Addendum Number Five
To The Drawings and Specifications for
EMS Post #1
RFB Bid Number: 26-0035, Sedgwick County, Kansas

Issued: September 22, 2026

You are hereby instructed to include in your bids the following changes and/or corrections to the Drawings and Specifications for the **Construction of the New EMS Post #1 – 3099 W. 13th Street North, Wichita, Kansas 67203.**

SHEET
A6.2
OF 1 SHEETS

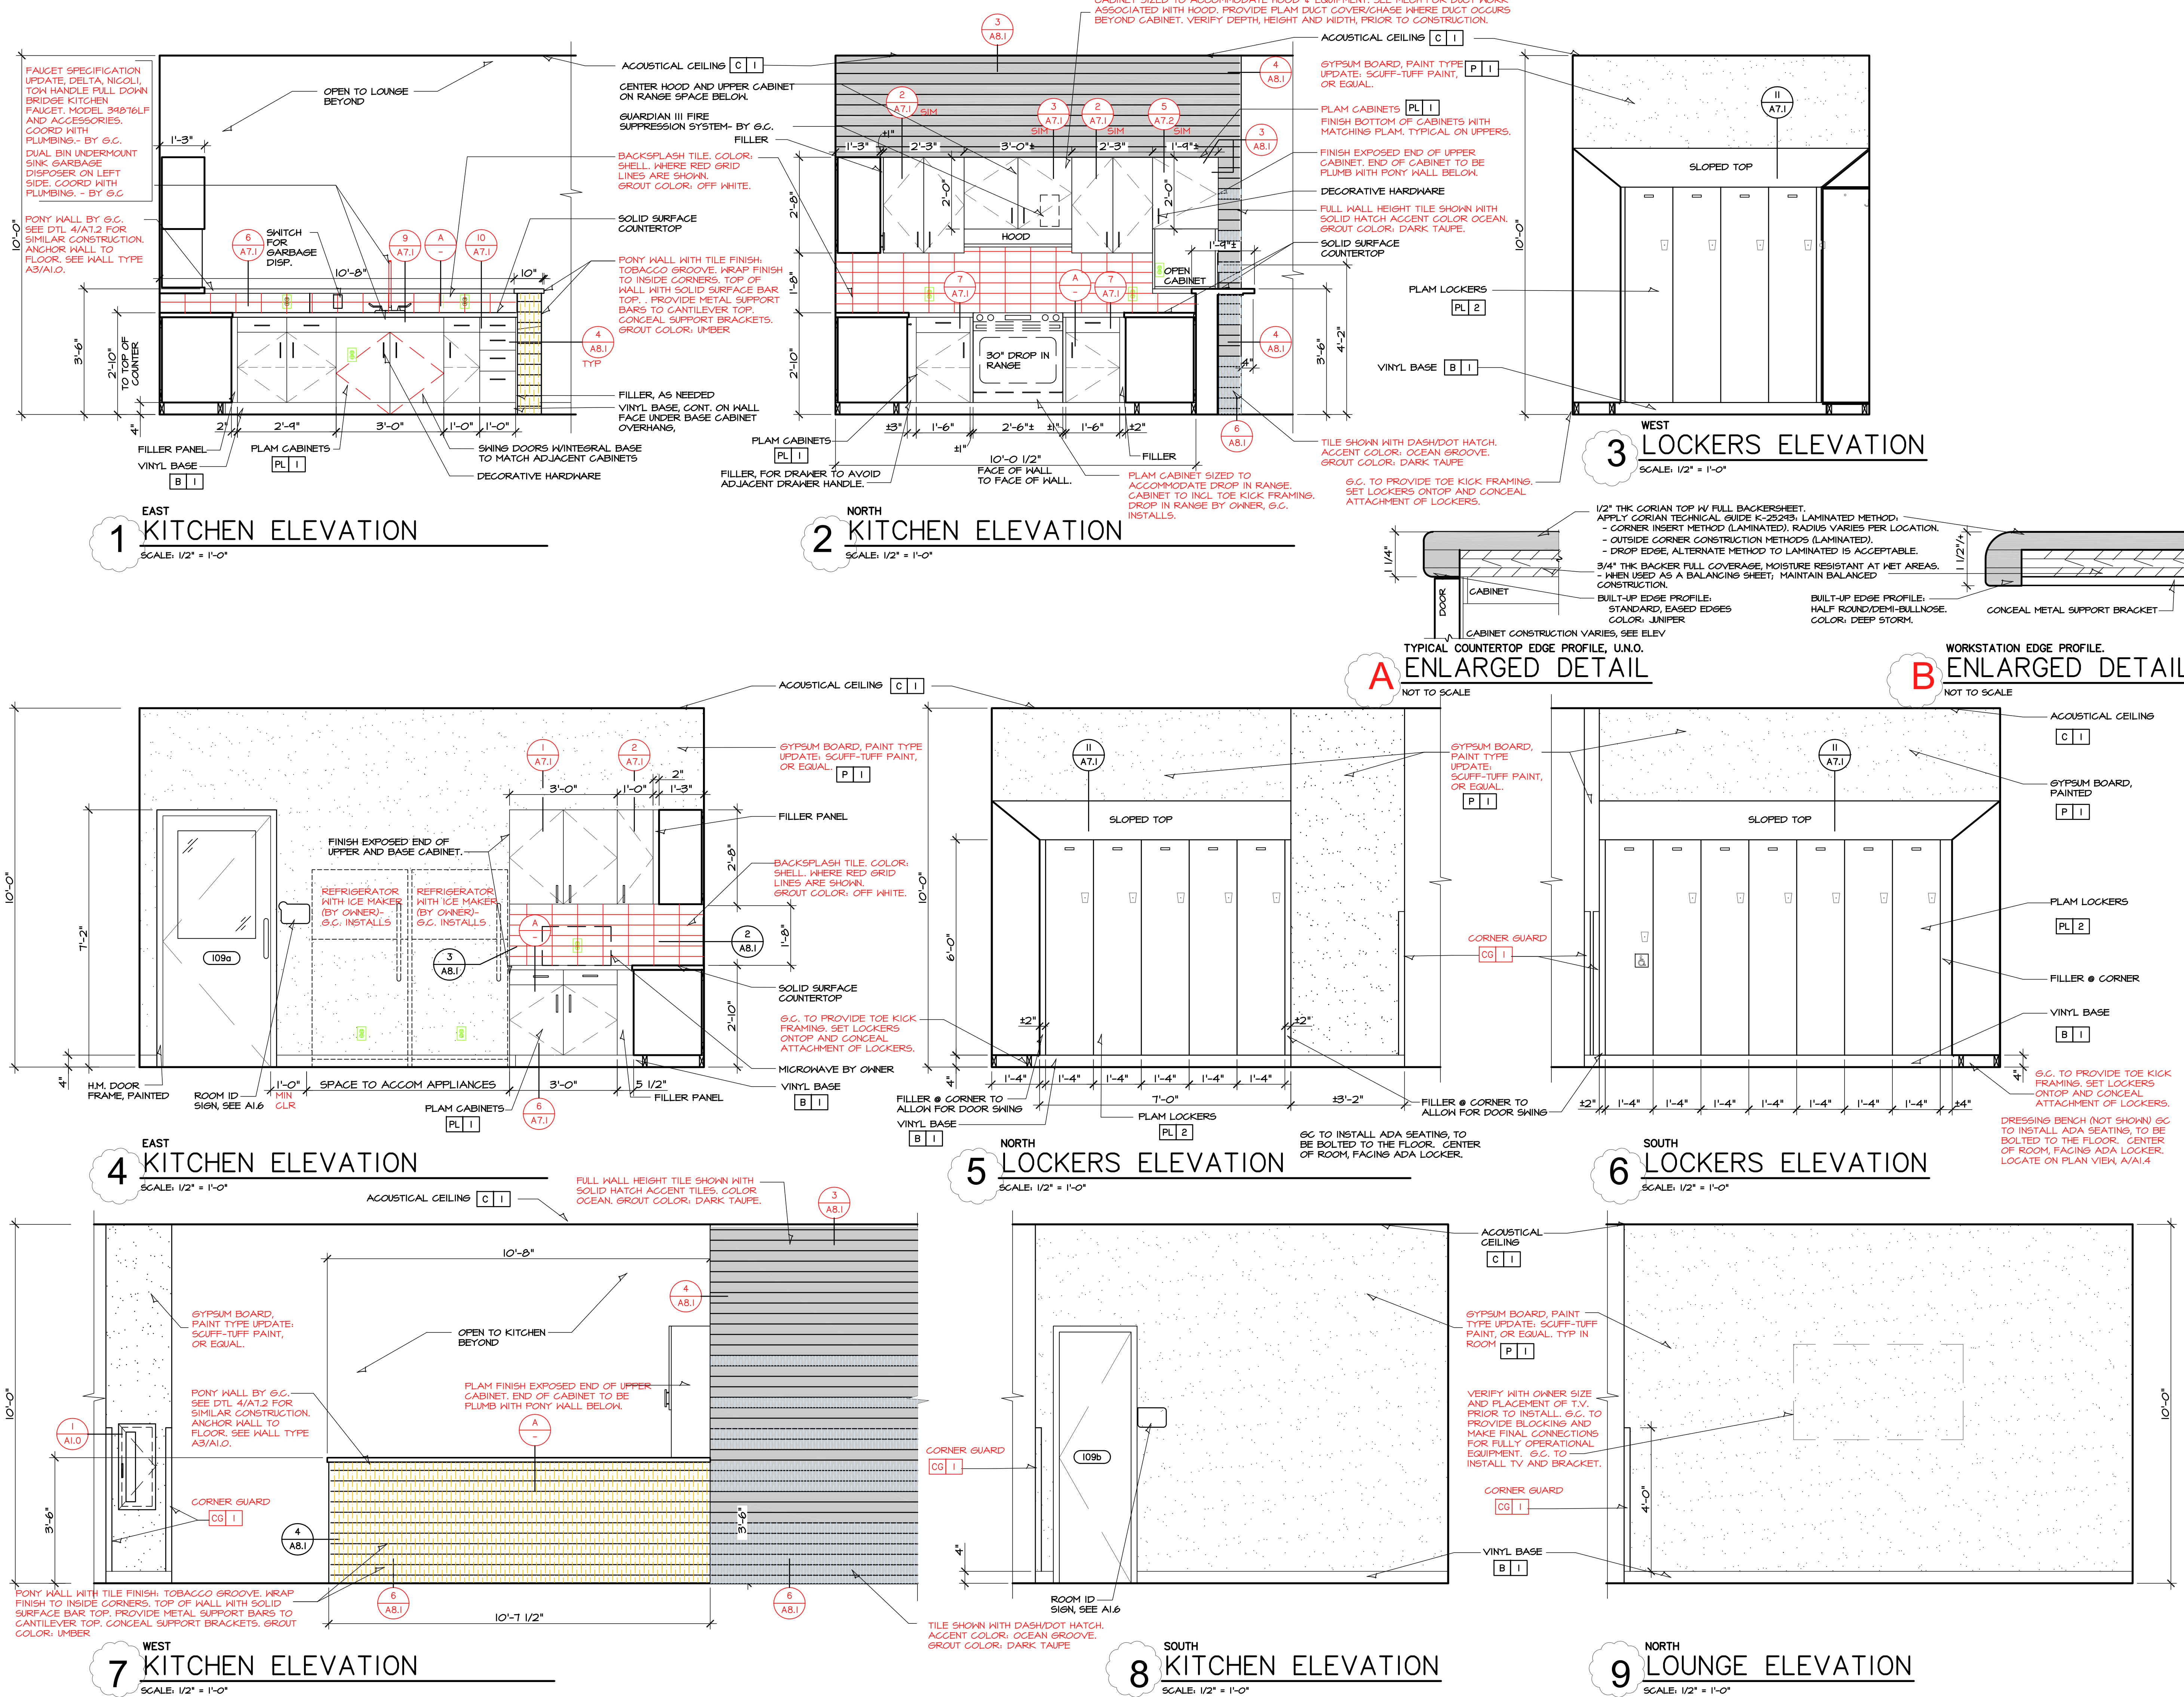
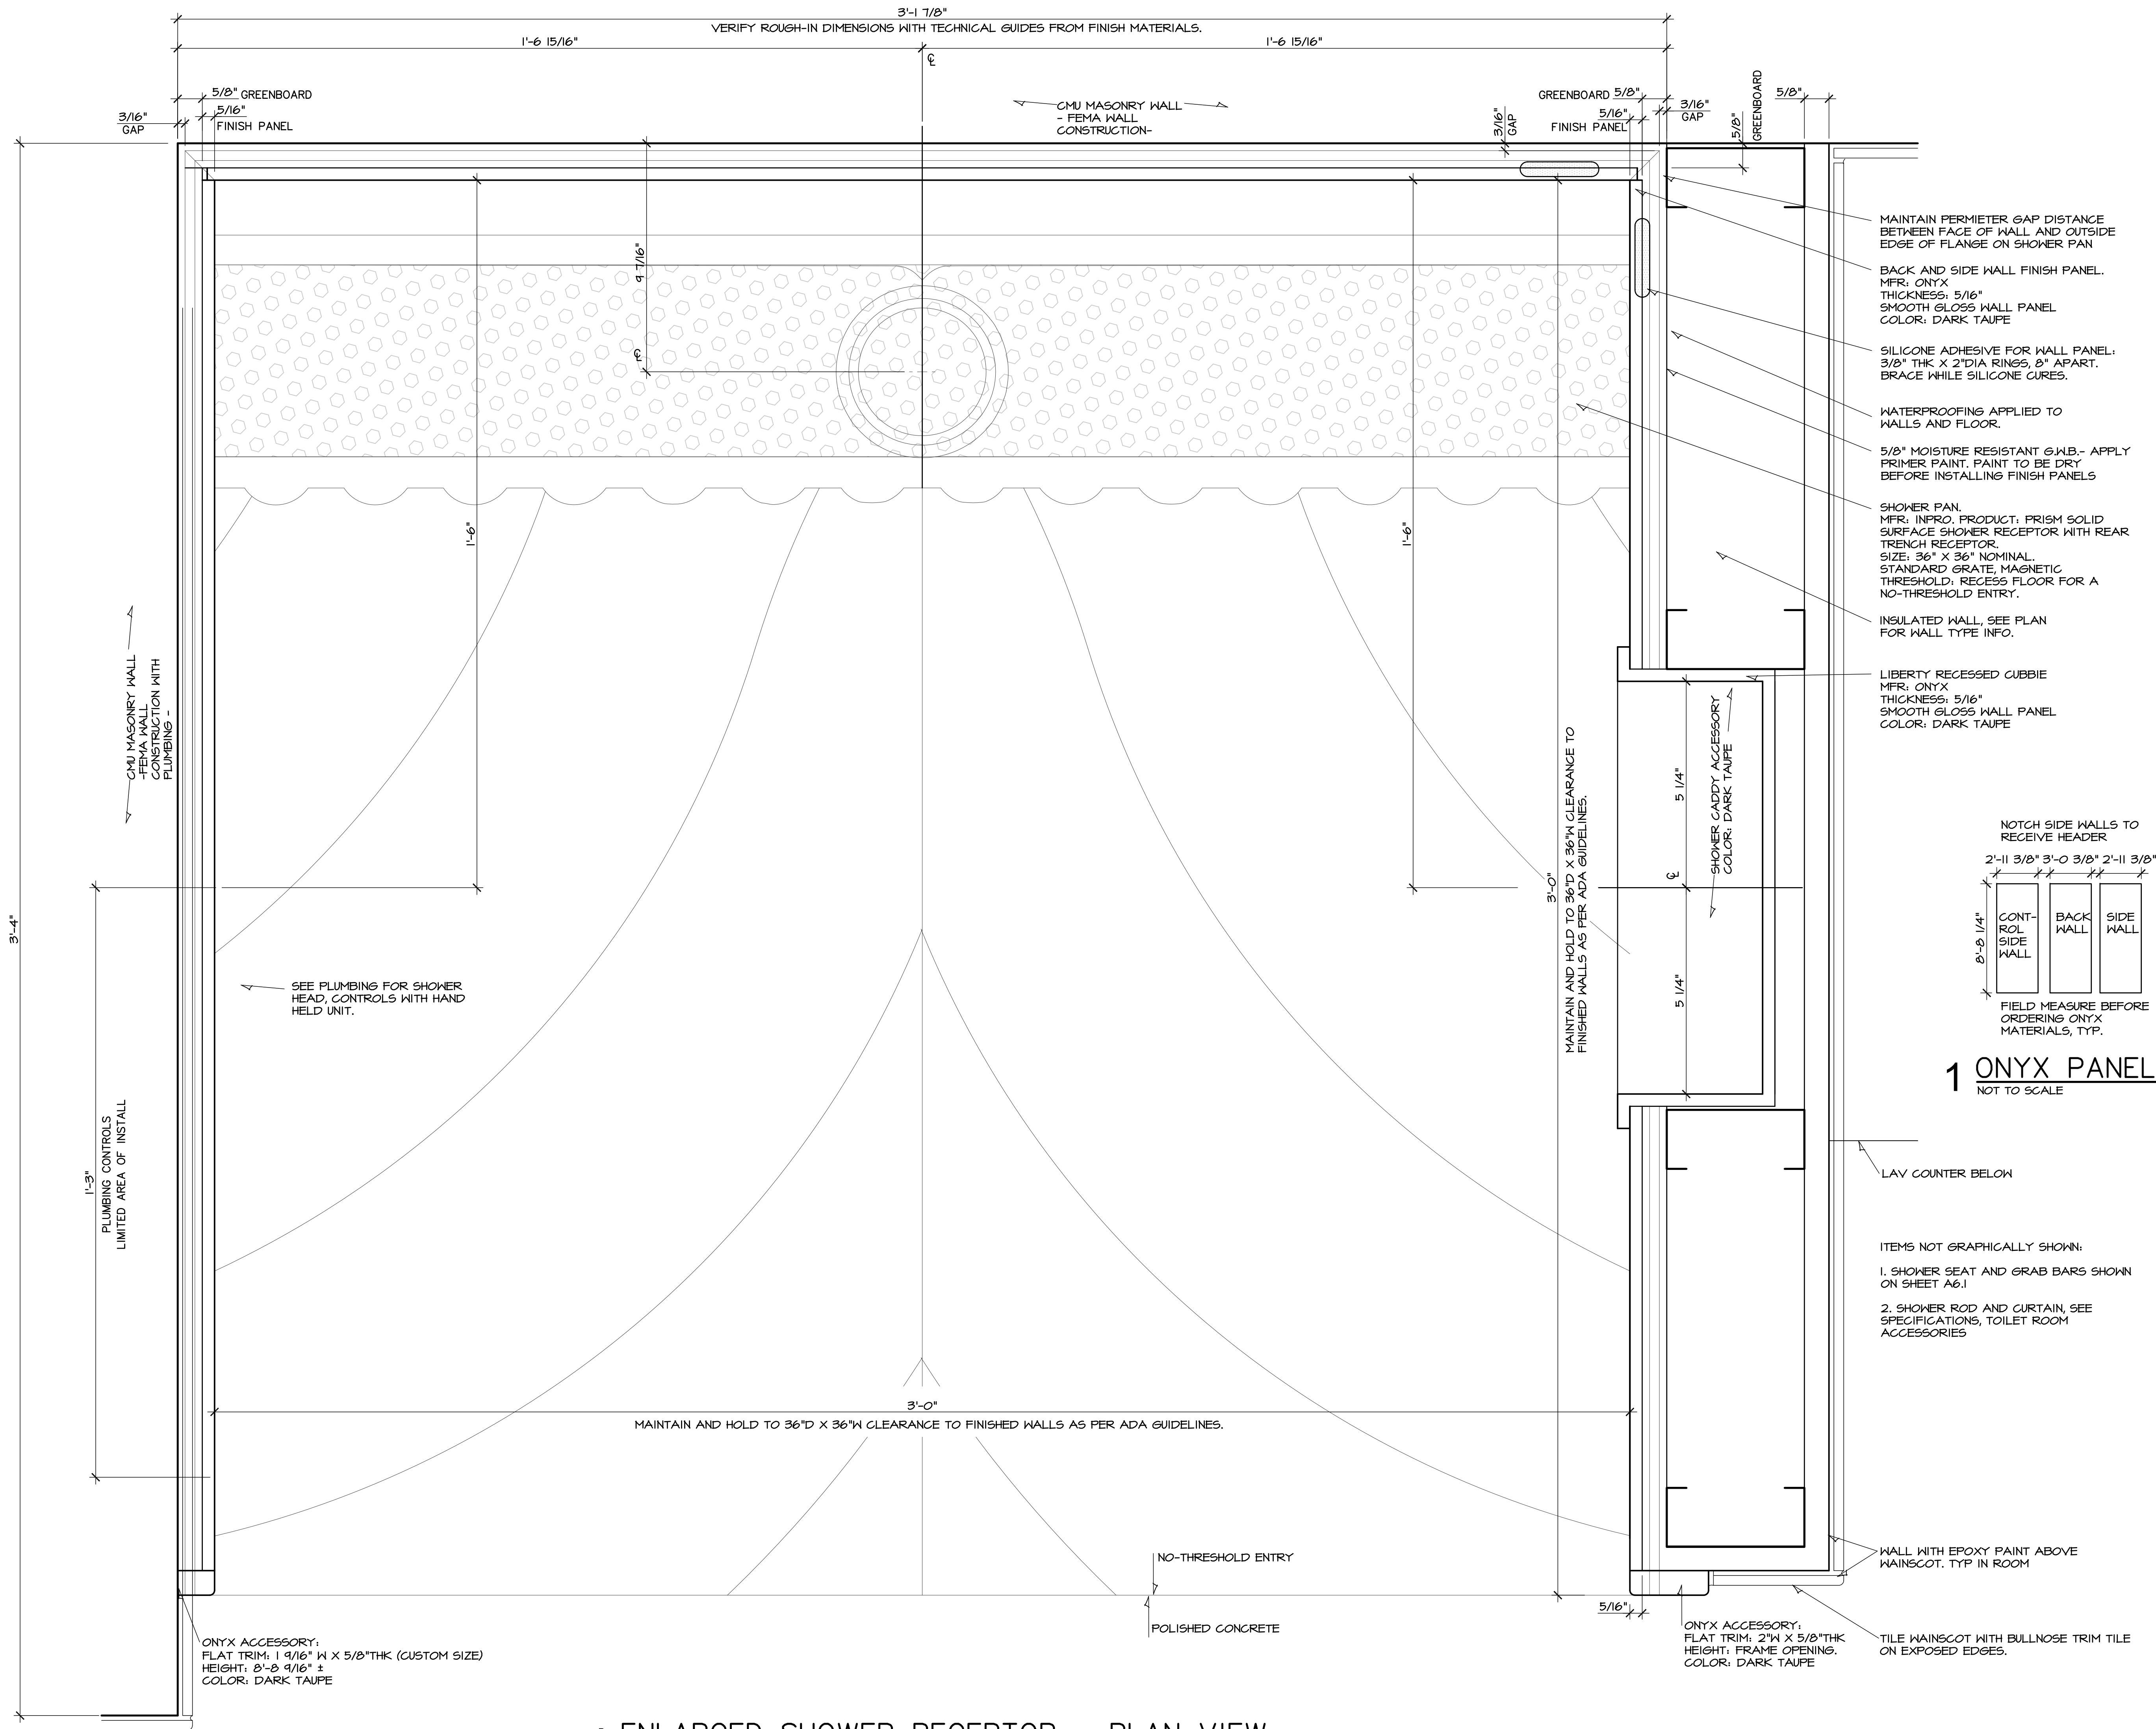
- 5. The blue/Ocean color tile application is the full exterior north wall of the entry recess as shown on Elevation A on sheet A4.1. The tile then extends into the building from the entry door to the kitchen. The tile then turns back to the west as a tile wainscot between the counter top to the bottom of the upper cabinets. Refer to the Floor Plan on Sheet A1.1, there is a dashed line that indicates the tile wall. The tile is also on the pony wall as a backslash. Refer to Elevations 1, 2 and 4 on Sheet A6.2

- 3.9 Sheet A6.1 + A6.2
The shower and finishes have been corrected.
These sheets are being reissued with this addendum.
- 3.10 Sheet A8.2 + Sheet A8.3
These sheets are being reissued with this addendum, detailing the shower.
